DRAINAGE CALCULATIONS
for
TEXACO EXPRESS LUBE
FOUR HILLS CENTER

RE: Tracts 1-A1, 1-B1 and 1-B2, Four Hills Village Shopping Center & Apartment Complex, Burger King/Texaco Station (City Drainage File L23/D22) and Texaco Express Lube (City Drainage File L23/D25)

RE: *TEXACO EXPRESS LUBE (L23-D25). GRADING AND DRAINAGE PLAN FOR SITE DEVELOPMENT PLAN FOR SUBDIVISION APPROVAL. ENGINEER'S STAMP DATED OCTOBER 29, 1997.*

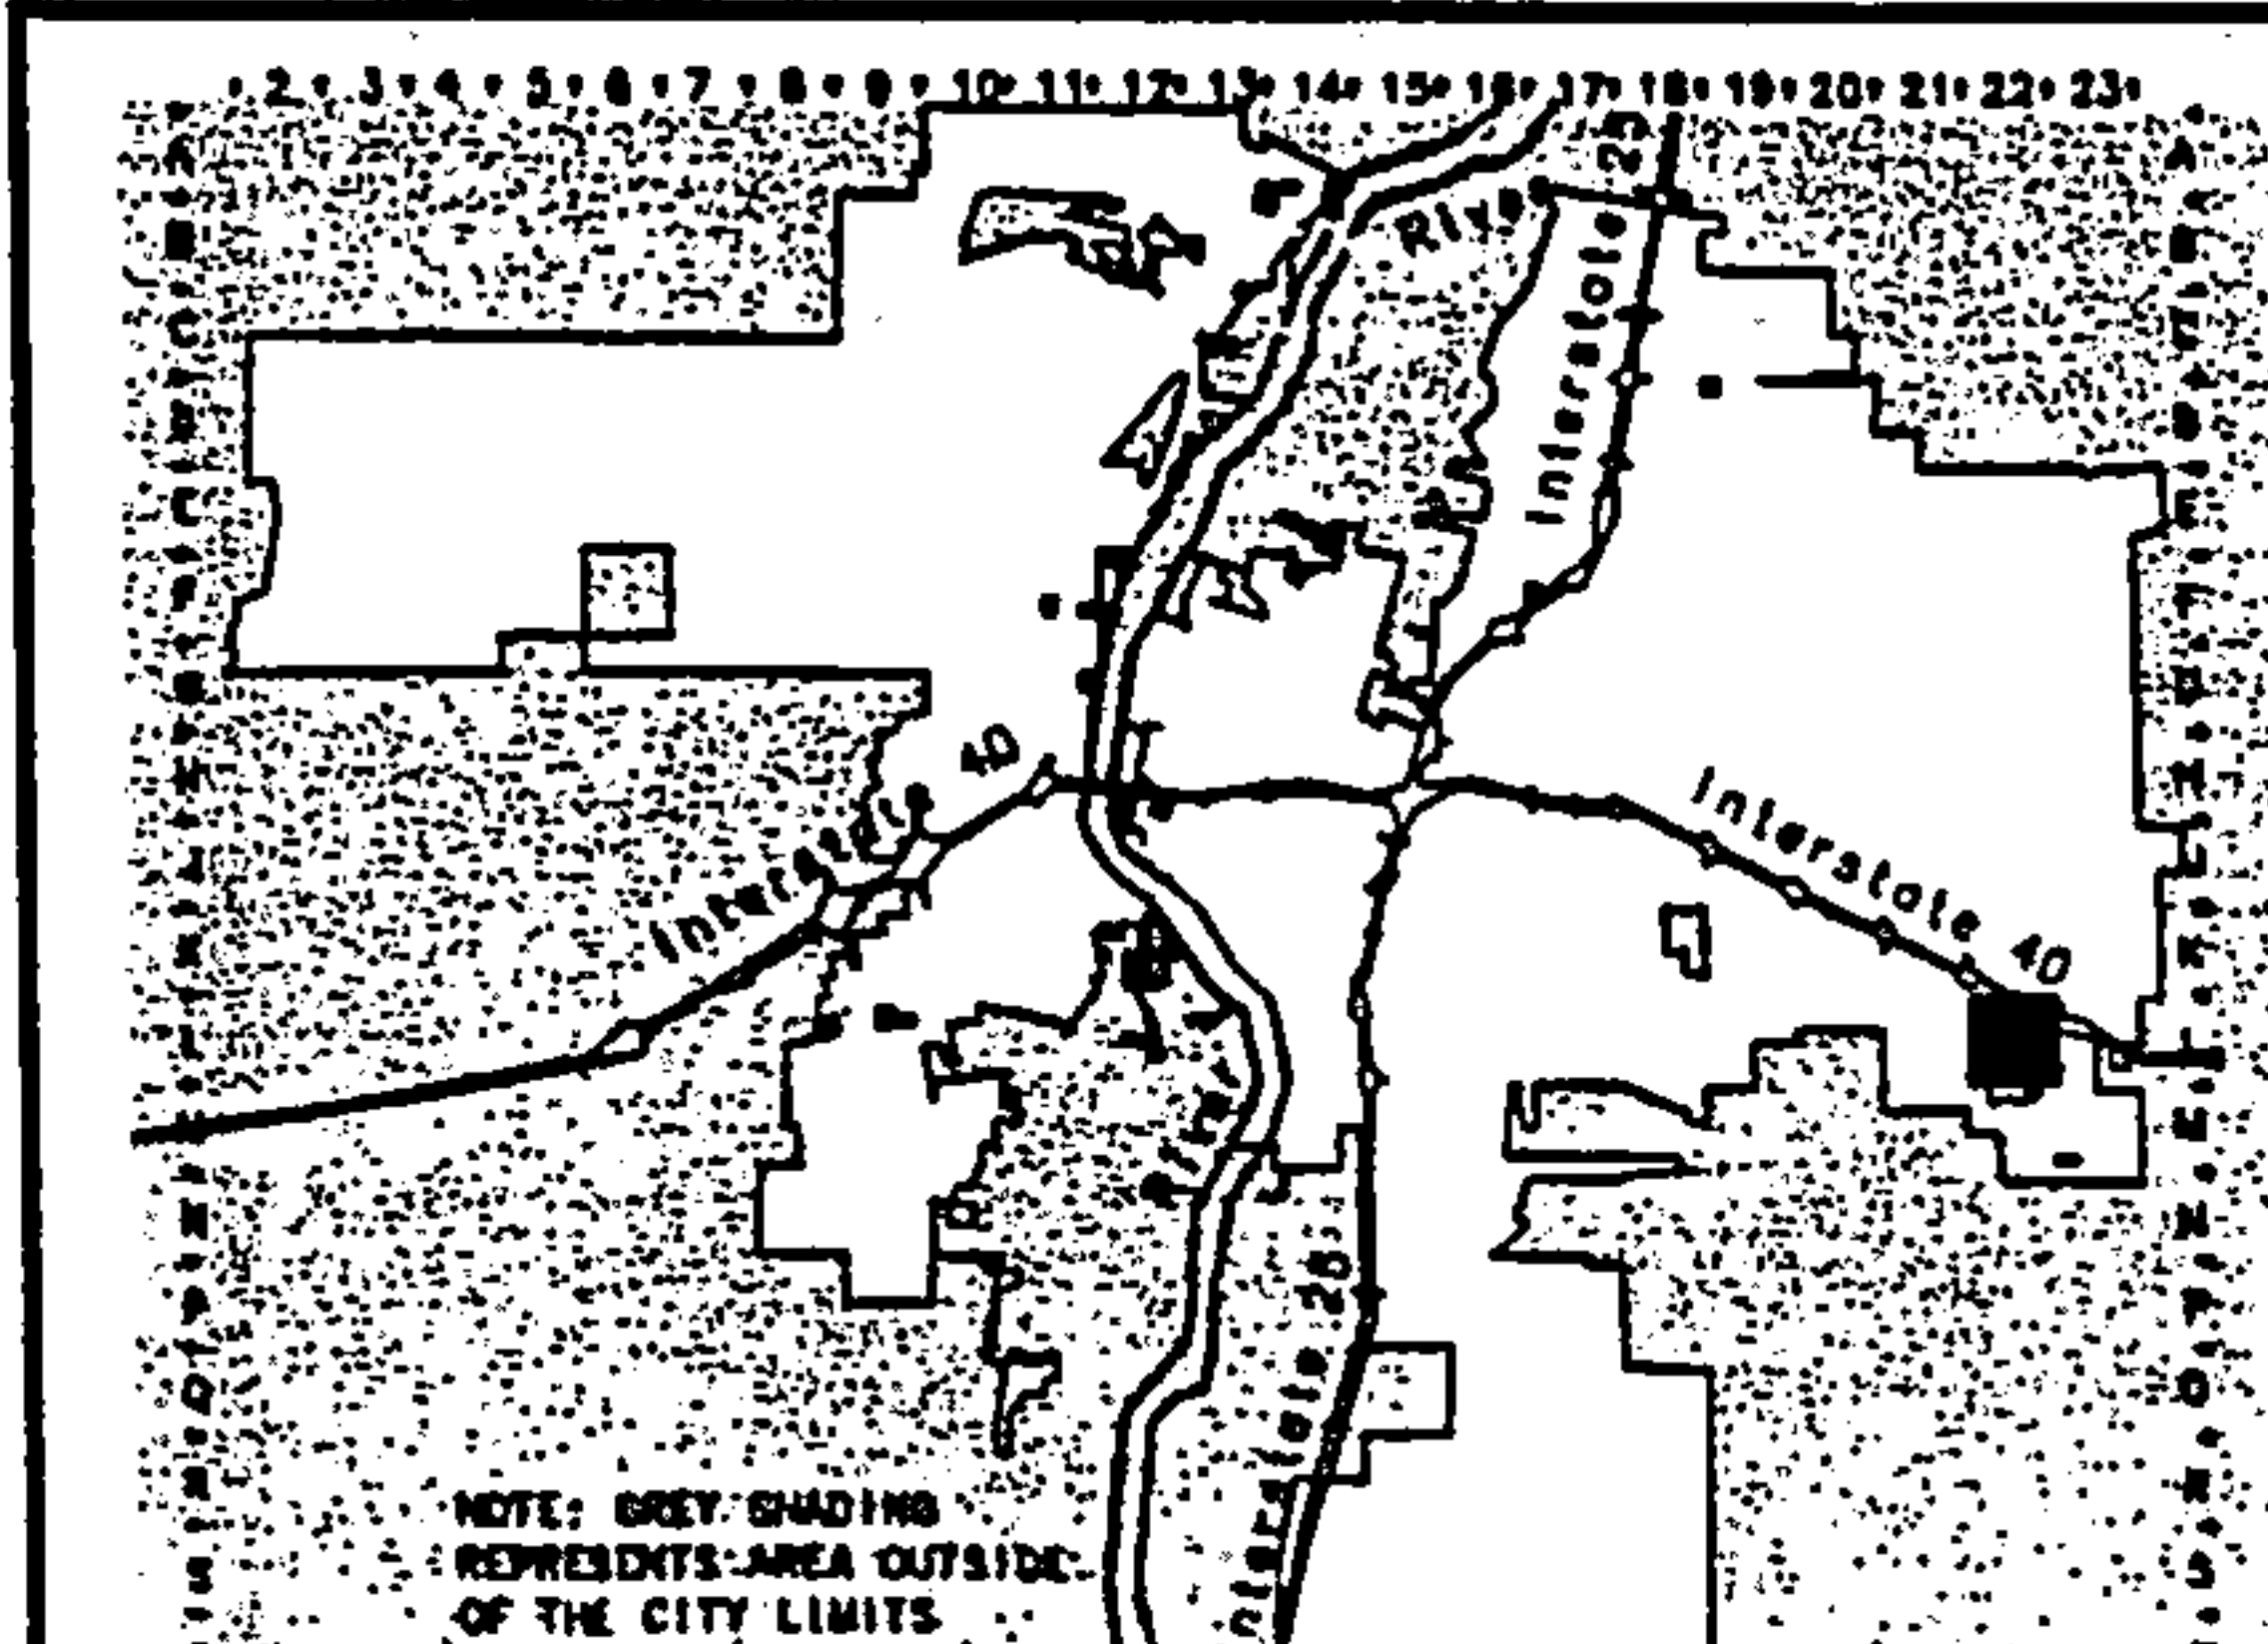
Complaint Description: Developer placed fill against garden walls.

Investigation-Comments:
Terrin Martin visited site 4-5-01.
see attached letter.

L-23-Z

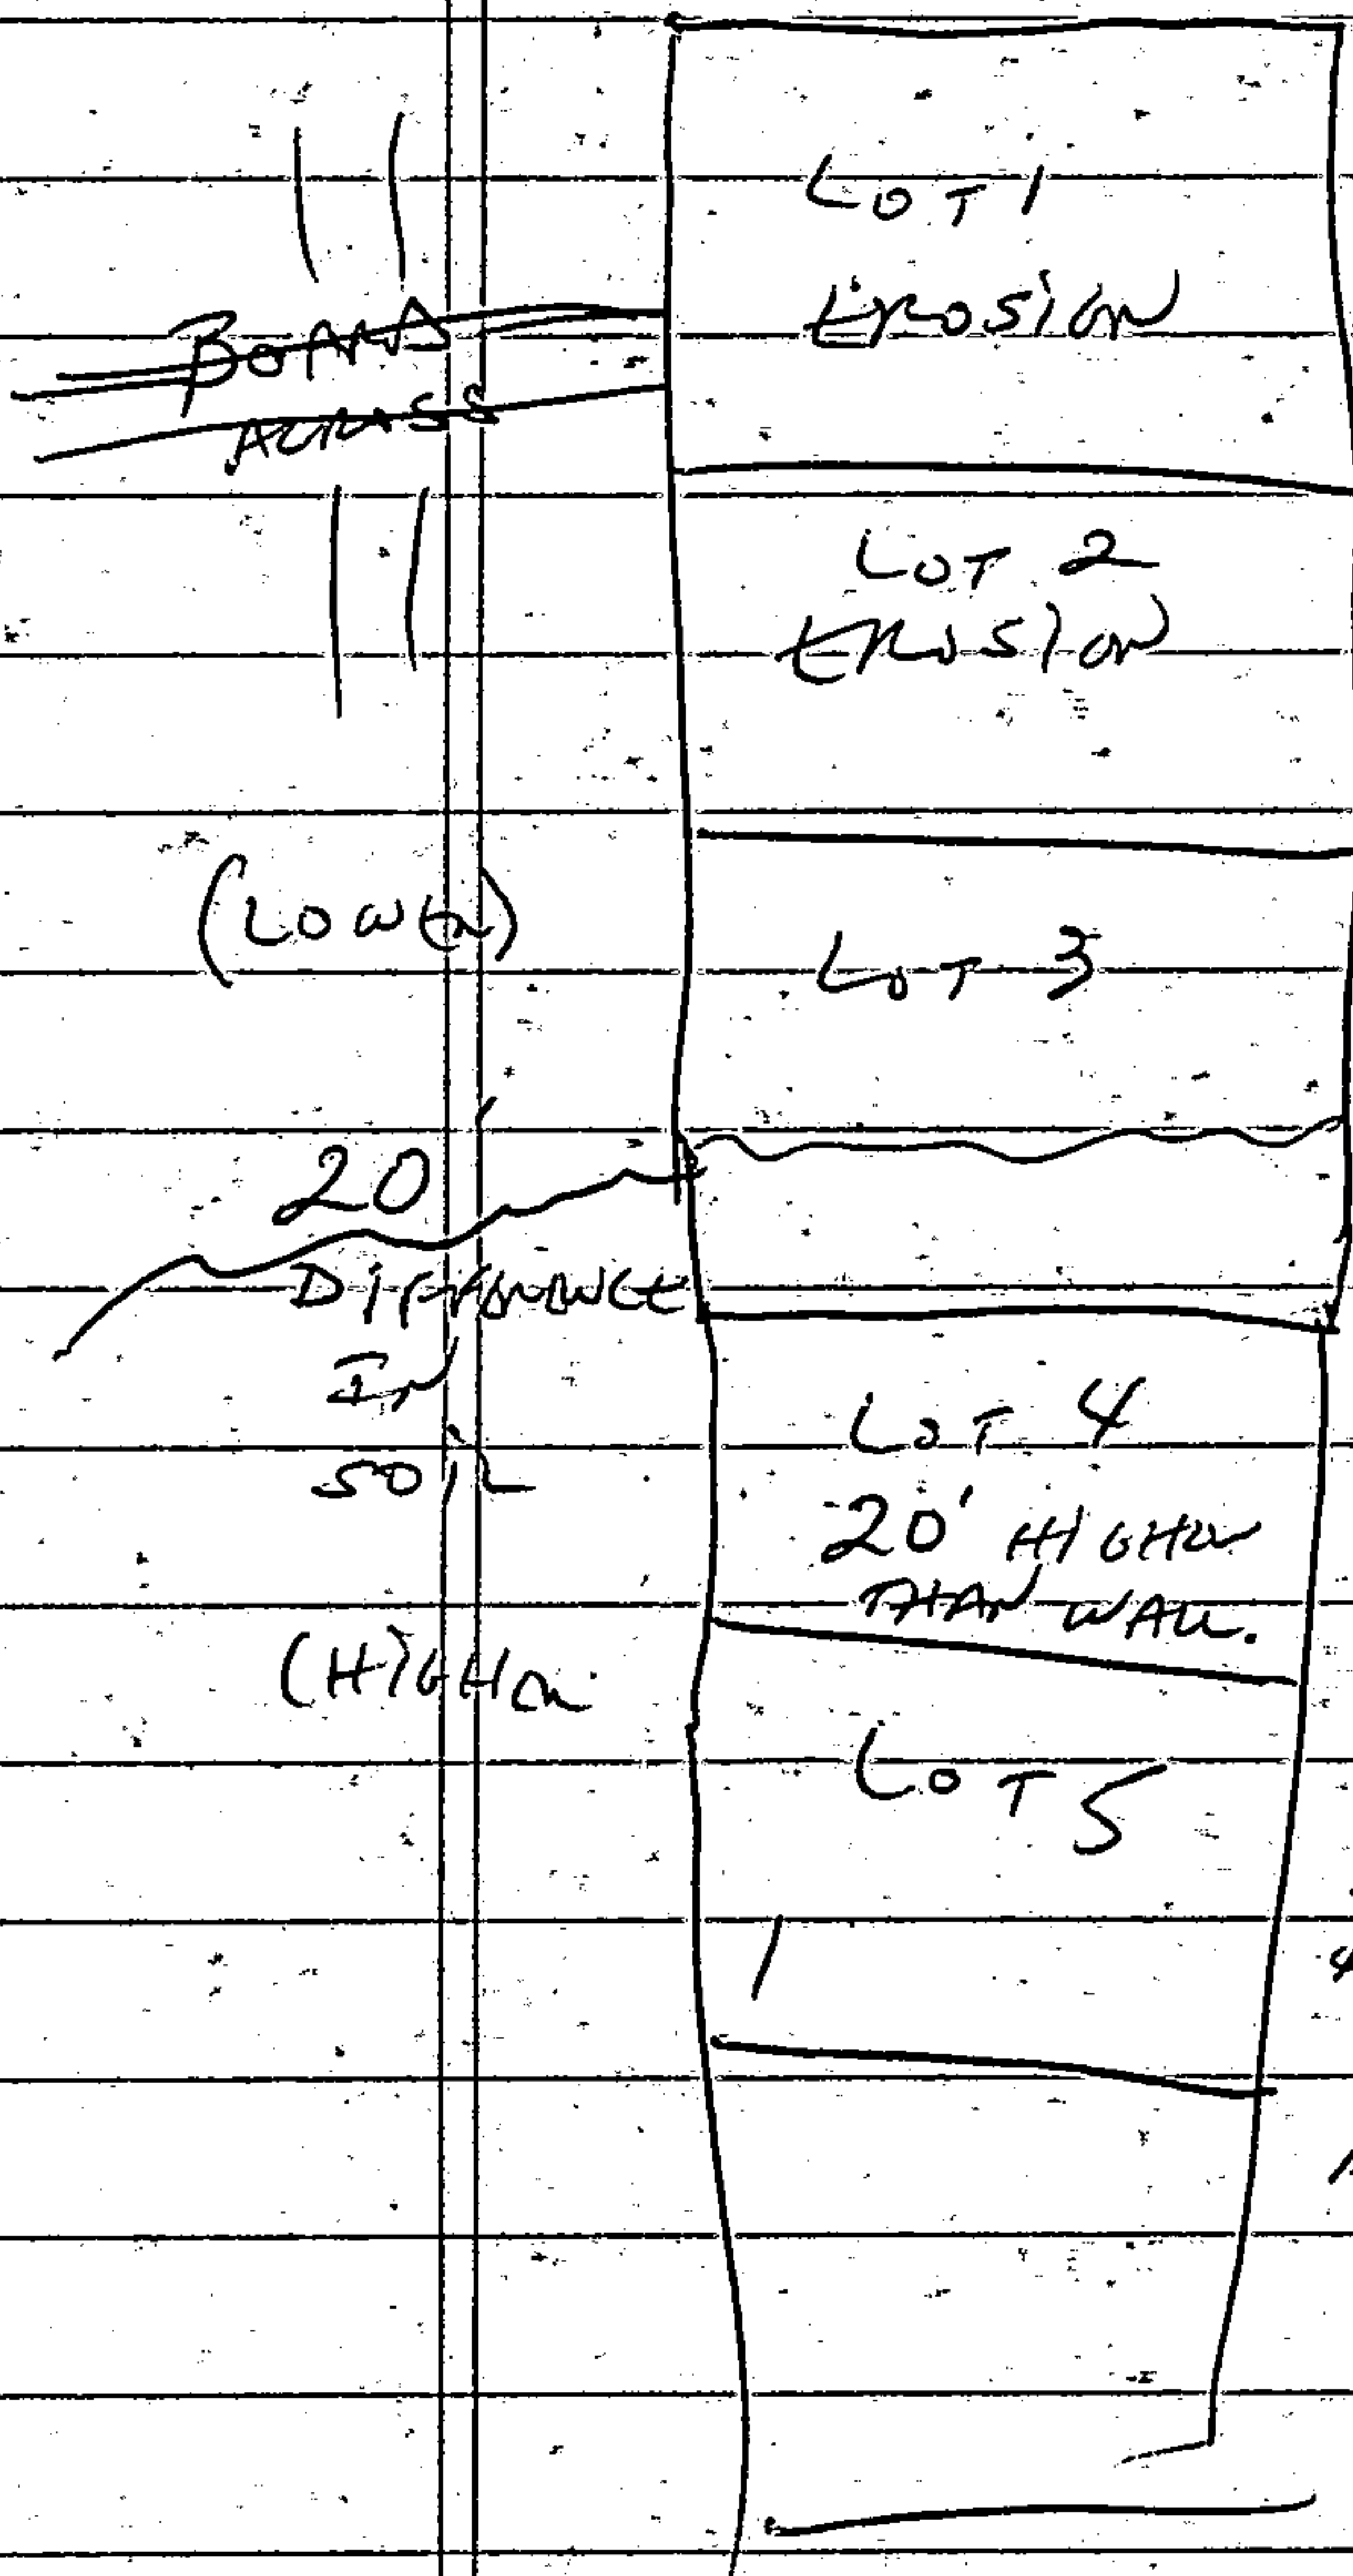
- MASS GRADING DIRECTLY TO ~~WEST~~ EAST
- NO ONE ON SITE.
- BECOMING A DUMPING GROUND FOR TRASH, FILL DIRT, ETC.
- SEVERE BUILD UP OF DIRT AGAINST GARDEN WALL, W/ SEVERE EROSION IN DIRECTION FROM NORTHWEST OF LOT, TO SOUTHEAST CORNER.
- FILL DIRT EXCEEDS GARDEN WALLS BY 20' IN PLACES.

SAFETY ISSUE (PARTY WALL)
LOST SIDE OF BACK VIEW.

BRICKS STACKED
AGAINST WALL.
AS
